AIRWORTHINESS DIRECTIVE - POWER SAILPLANE

GFA/AD/87 SPORTAVIA 1

Type Affected: Scheibe SF 25C

Aft elevator support - fuselage

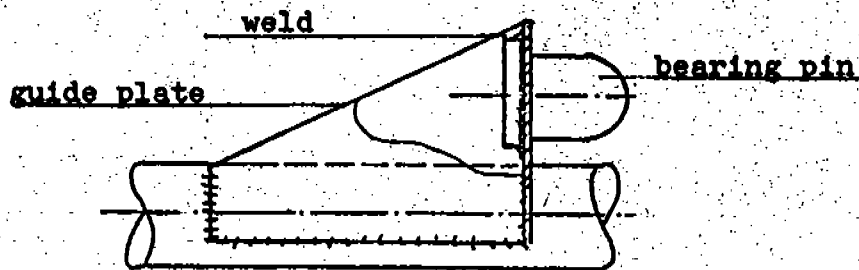
Affected Area: Elevator support has been reported as possibly defective (Sportavia TM S-02-77)

Reason: Loosening of the aft bearing pin which is secured in the support fitting by means of tack welding.

1. Prior to next flight after disassembly of the elevator, check tight fit of the bearing pin in the fitting by tapping the bearing pin end slightly with a plastic hammer. Slight resilience will show that the weld is not in sound condition.
2. If the weld is not satisfactory, cut the chamfered guide plate so as to gain access to the pin head which is to be welded to the pin holder (using the W I G procedure welding wire 1.7734.2).
